DELEGATED APPLICATION REPORT

SITE ADDRESS: Leighton Park School, Shinfield Road, Reading, RG2 7DE

APPLICATION NUMBER: PL/25/0758

PROPOSAL: Erection of an entrance lodge and associated access.

Existing (left) and proposed (right) site plans

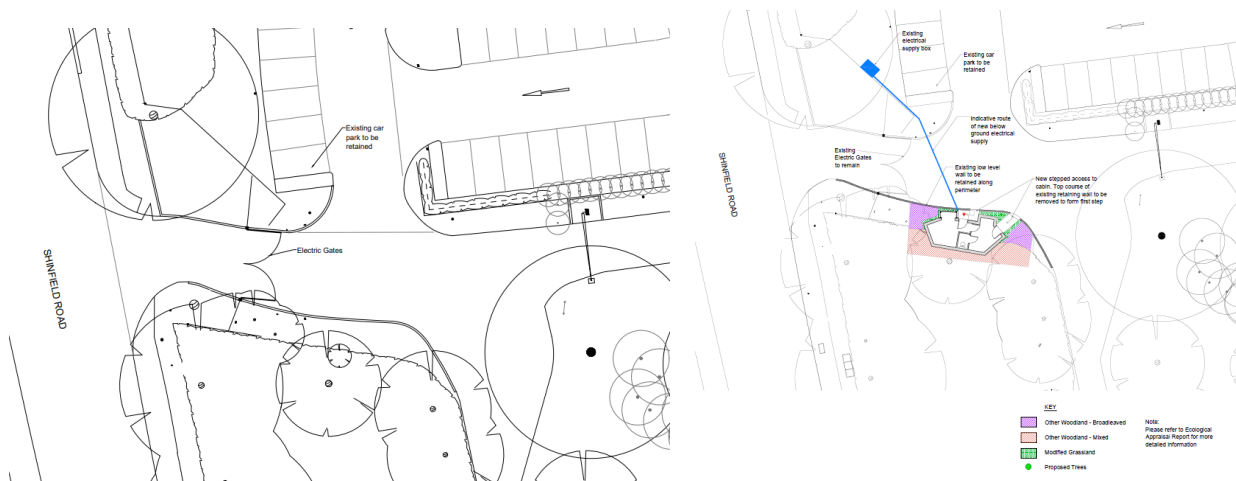
- 4.1.7 As per the comments above, the only matter relating to services that required clarity was the electricity supply and this is shown on the Proposed Site plan and mentioned in the Tree Report's introduction and is acceptable.

- 4.1.9 With regard to the steps, these are confirmed on the Proposed Elevations and Proposed Site Plan and are as discussed. These are unfortunately not included in the Tree Report as suggested, but as any incursion is so minimal, this will be accepted.

- 4.1.12 Following the submission of an updated site plan and amended biodiversity based information on 13/04/2026, RBC Natural Environment advised that now that additional on-site soft landscaping was proposed (but the exact detail was not confirmed) the following landscaping details condition would also be necessary:

Prior to the first use of the building hereby approved, a scheme of soft landscaping, based on indicative planting shown on 240119-20-101 Rev H – Proposed Site Plan, as received 13/04/2026 shall be submitted to and approved in writing by the Local Planning Authority. This scheme shall specify species, planting sizes, spacing and numbers of trees/shrubs to be planted, tree pit specifications, method of planting within Root Protection Areas, and must include a maintenance programme detailing all operations to be carried out in order to allow successful establishment of planting.

Proposed floor plan and roof plan

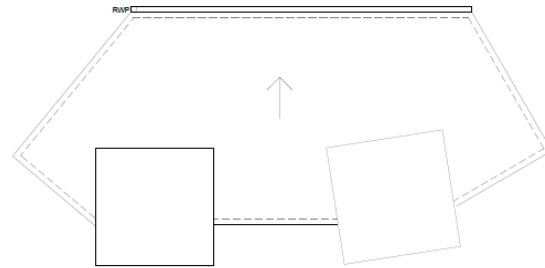
7.3.1 The entrance lodge building would be a single storey structure set back from the Shinfield Road highway within the Leighton Park site. It would comprise a flat roof and be 3.05m in height. The entrance lodge is somewhat irregular in shape, but the applicant has explained that this is required for the function proposed, allowing visibility from the entrance for those visiting the site. As such, in this context, this is accepted, with a maximum length of 9.6m and width of 5.3m.

Proposed elevation plans

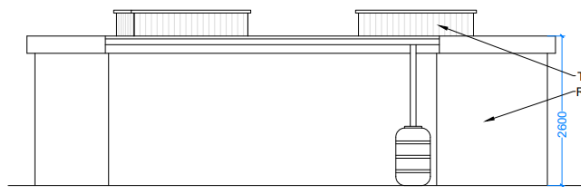
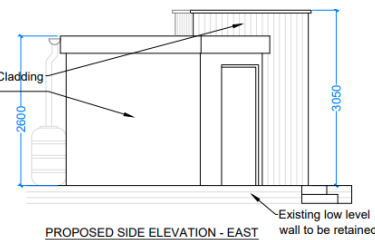
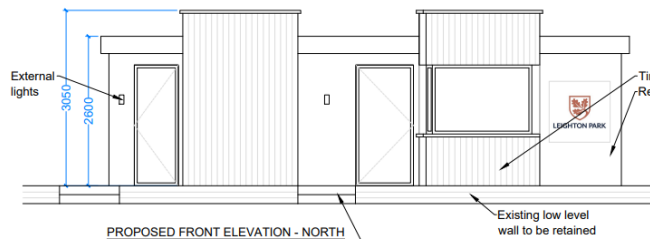
- 4.1.8 With regard to foundations, screw piles are specified, with the Indicative Proposed Foundation drawing confirming that these will result in the cabin being above ground level and that there is flexibility to move pile locations should tree roots be encountered. The Proposed Elevation drawing unfortunately makes no reference to screw piles or indicates them in any way by the cabin being shown above ground level or stating they will be used, which would have been helpful, as originally suggested.

7.3.3 The submission confirms that the structure will be a combination of timber cladding (where the north elevation juts out), render (as the predominant facing material) and fairly large expanses of glazing at the angled element towards the site entrance. There are also two doors and a fairly prominent roof capping, for which no indication of materials have been stated. The applicant considers that the entrance lodge would provide a modern and high quality design. Officers are content that the proposed design appears to align satisfactorily with the character and appearance of the area, but do consider it reasonable and necessary for the proposed material details of all facing materials to be secured via condition to ensure that the high quality design envisaged by the applicant actually occurs in practice and to ensure that the proposal accords with Policies CC7 and EN13.

- 7.3.4 It is also noted that the front elevation plan references some lighting is proposed, with the applicant stating that this is for security and safety. Further details of the lighting, mindful of the sensitive ecological location as well as general amenity considerations, will be secured via condition. The elevation plan also indicates Leighton Park related signage. This application is solely for planning permission and it has not been considered whether separate advertisement consent would be required. Accordingly, an informative will be included on the decision notice specifying that this permission is notwithstanding any possible separate future advertisement consent for signage, as shown on the elevation plan.

8. Prior to the first use of the building hereby approved, details of the proposed external lighting as shown on the north elevation of approved plan 240119-40-101 Rev B – Proposed Elevations, as received 21/11/2025, shall be submitted to and approved in writing by the local planning authority. Details shall include a) light levels b) coverage and c) hours of operation. Thereafter the external lighting shall be maintained and operated in accordance with these approved details.
